RE: CRIST ELECTRIC GENERATING PLANT
REQUEST FOR ADDITIONAL INFORMATION RESPONSE
UNIT # 7 ESP & SCR Project No: 0330045-005-AC

GULF POWER'S RESPONSE TO FDEP'S REQUEST FOR ADDITIONAL INFORMATION DATED JANUARY 22, 2003 UNIT 7 ESP/SCR PROJECT - Project No: 0330045-005-AC

Re: **Request for Additional Information**
Project No. 0330045-005-AC
Crist Unit 7 ESP/SCR Project

Attachment B
ESP & SCR Schedules

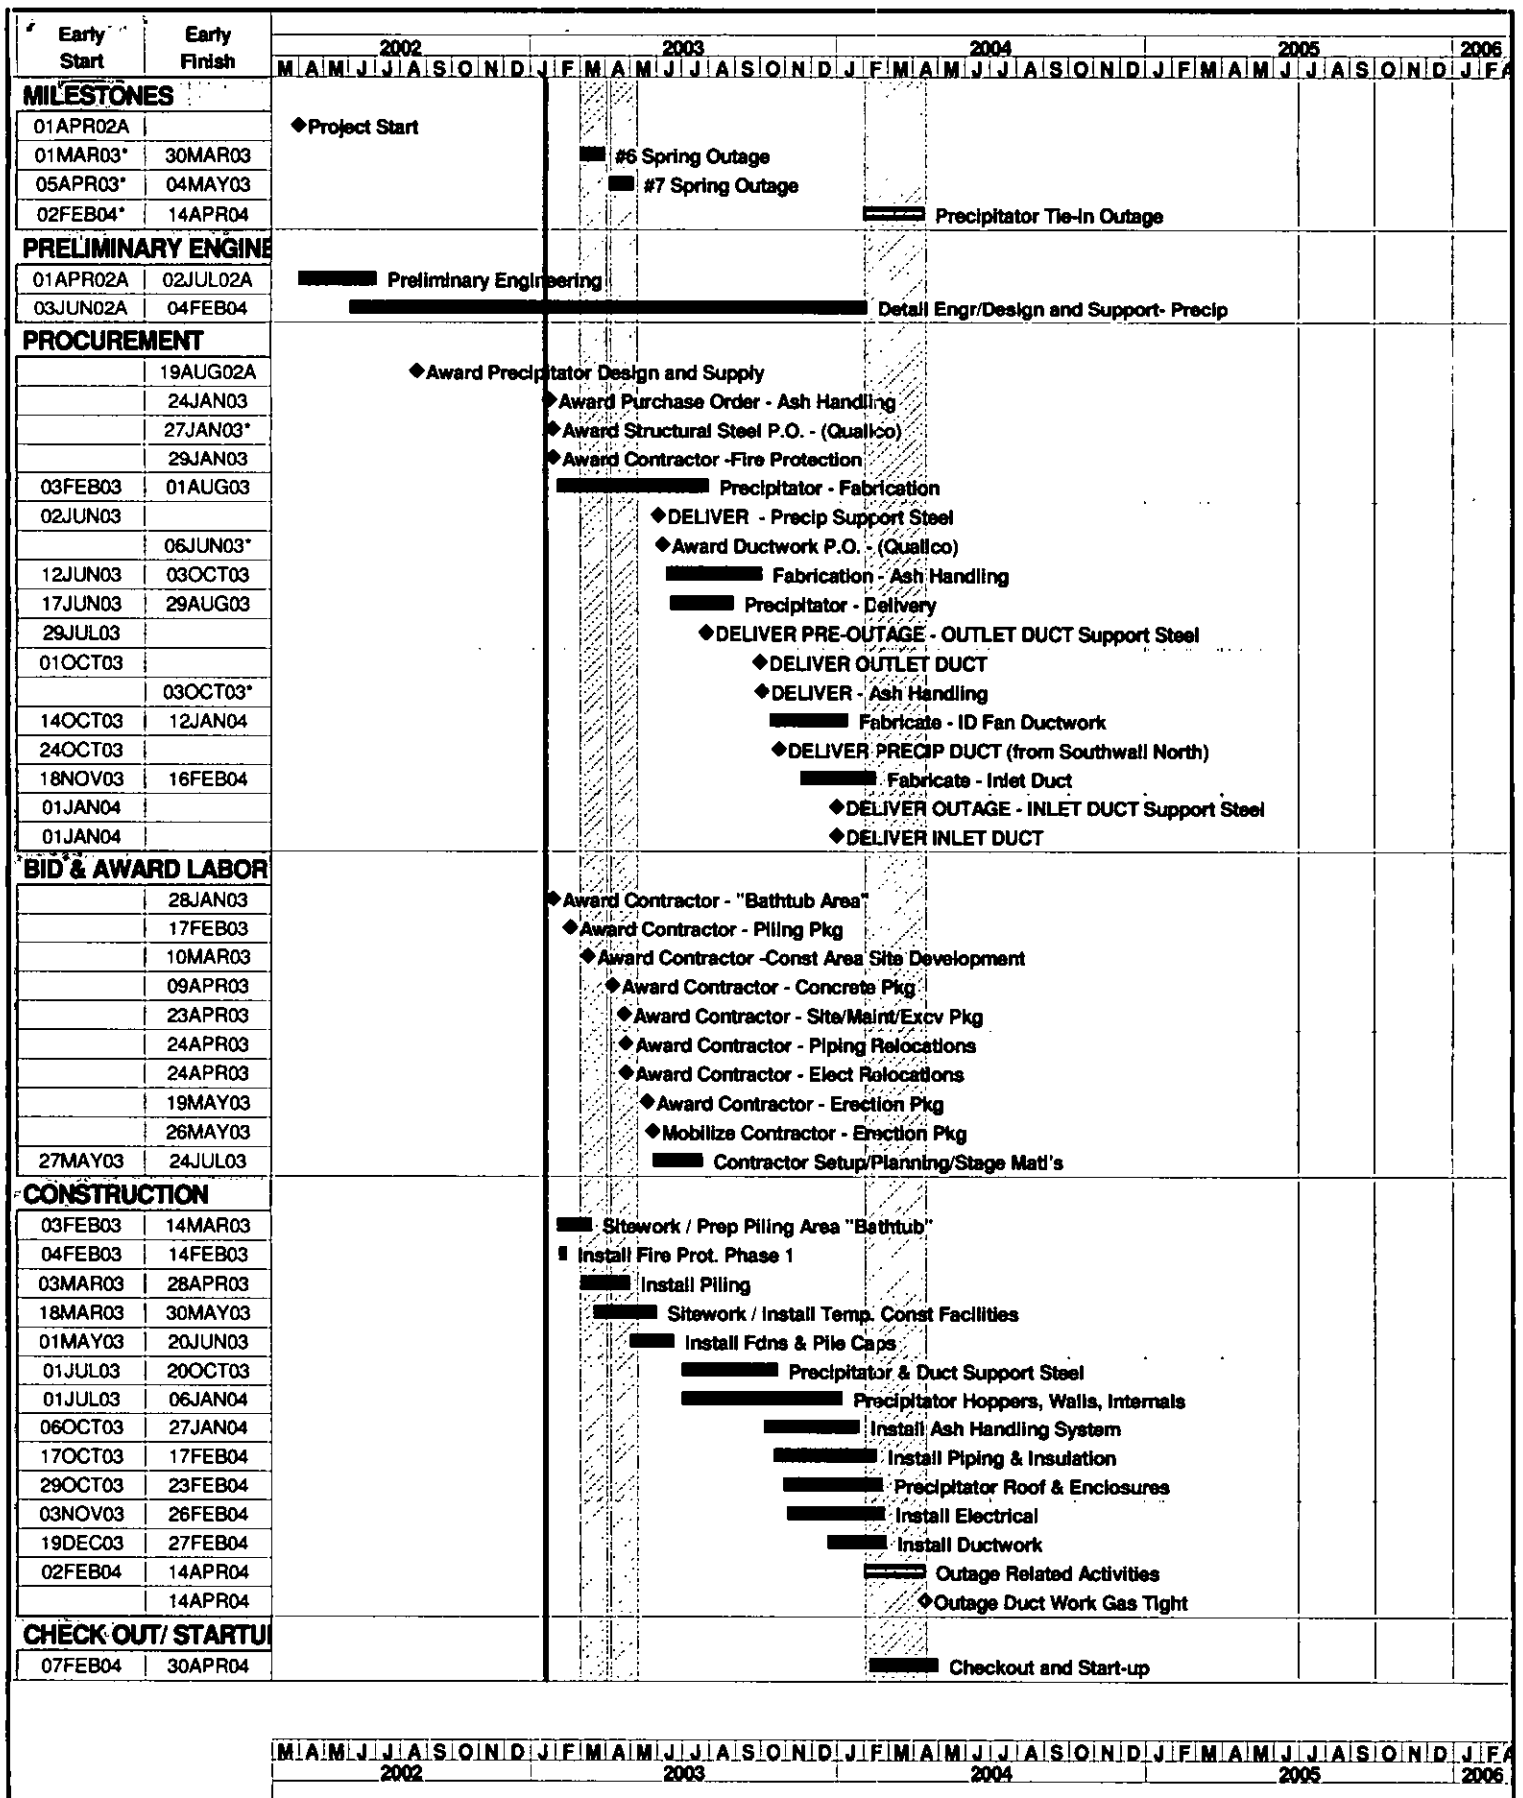
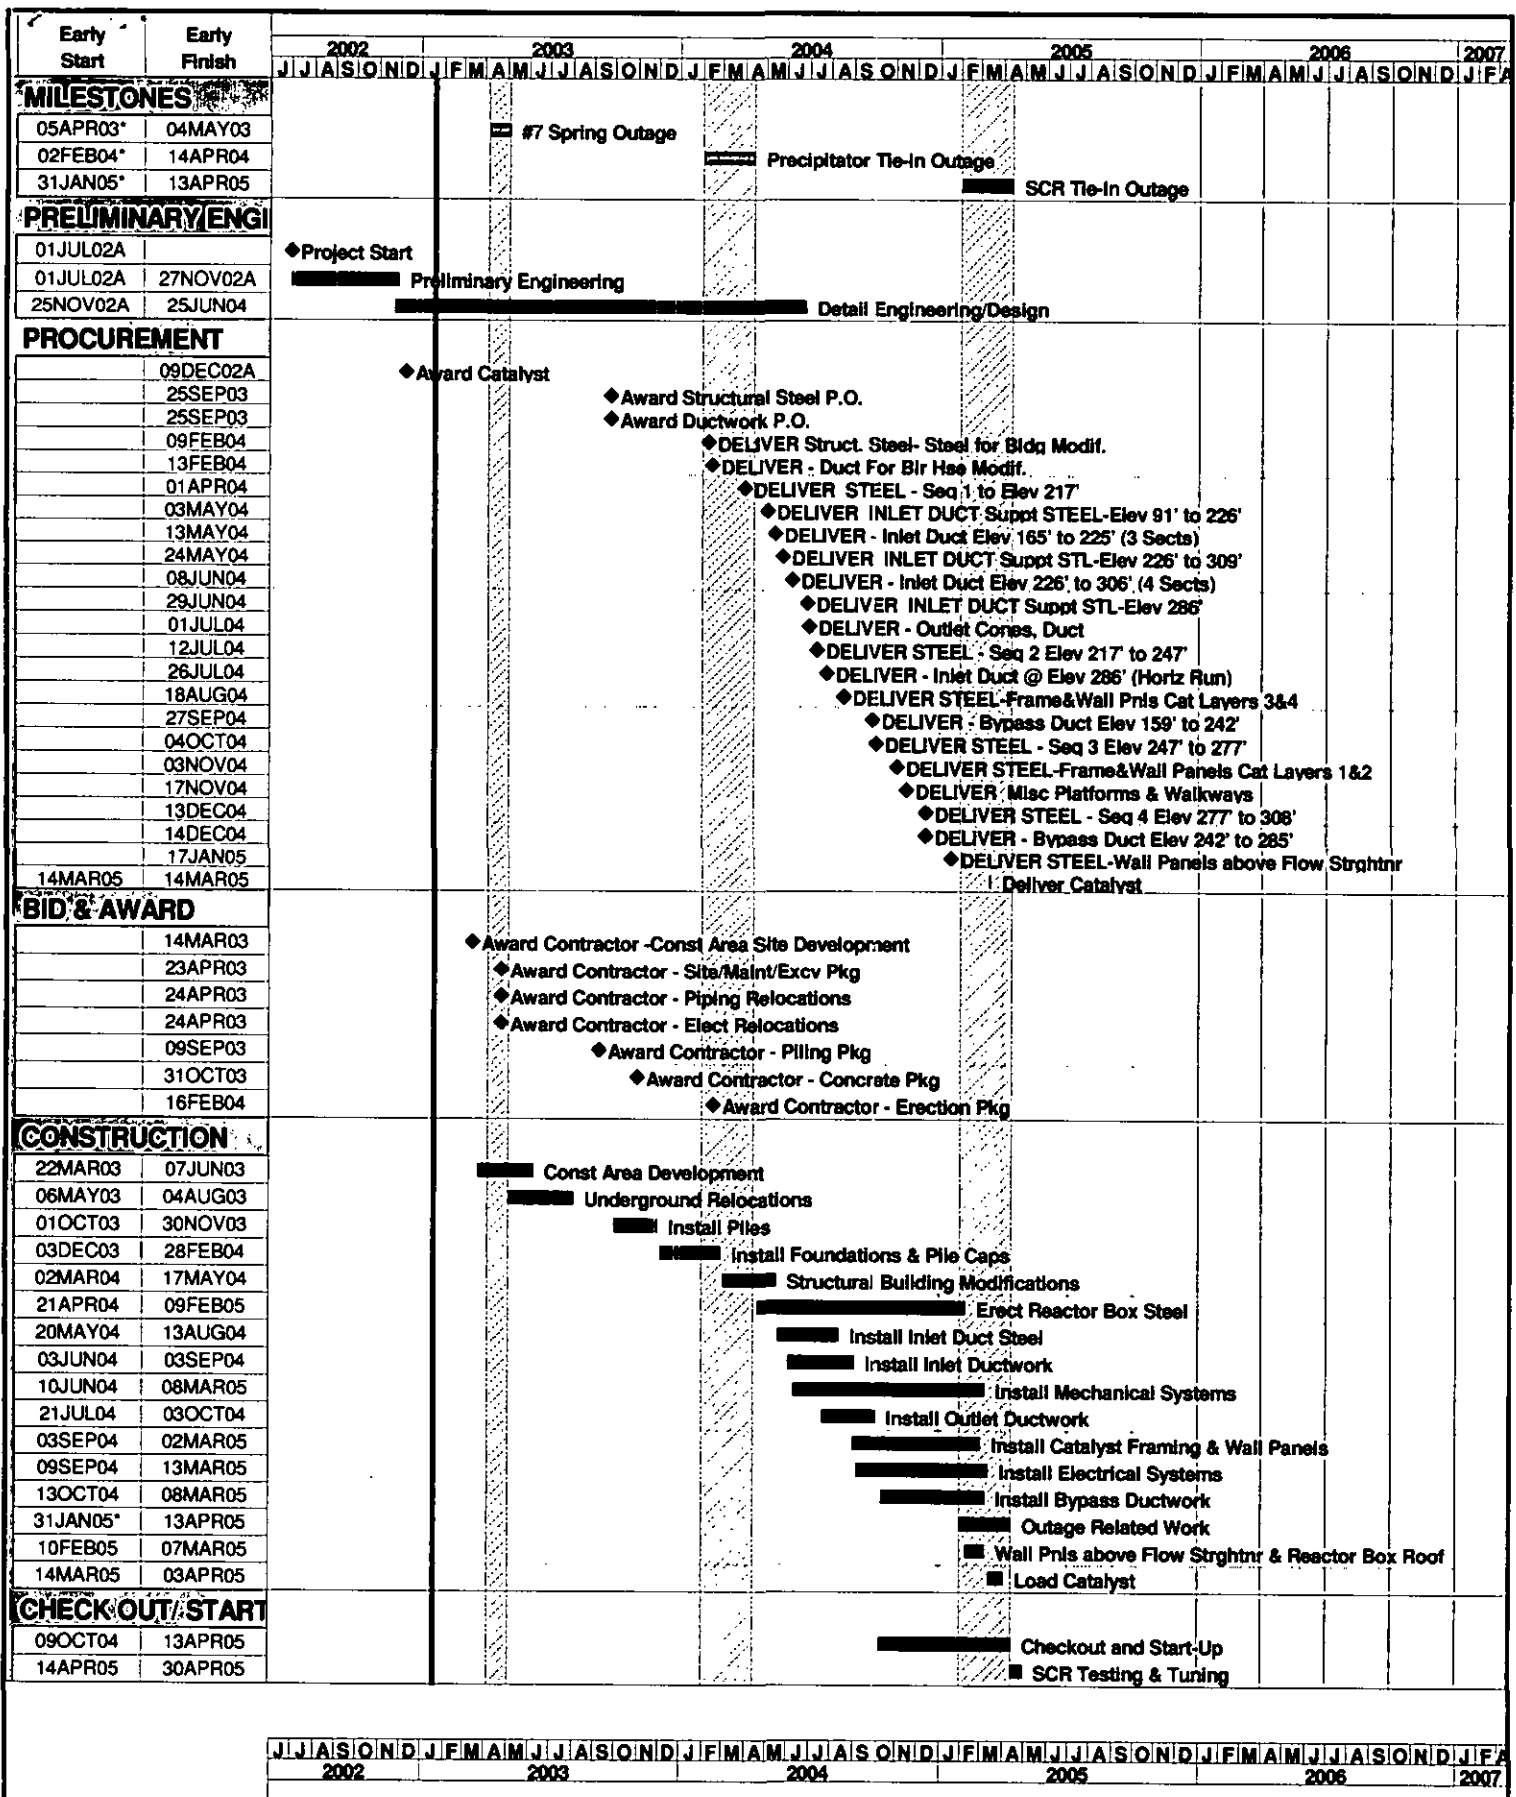
5. **Schedule**: Provide an updated project construction schedule similar to that shown in "Exhibit A" of the Gulf Power/DEP agreement.

See "Attachment B" summary schedules for the precipitator and the SCR. Note this schedule is the current plan and is subject to revision to accommodate unit outage scheduling, fabrication and delivery of components and actual construction activities.
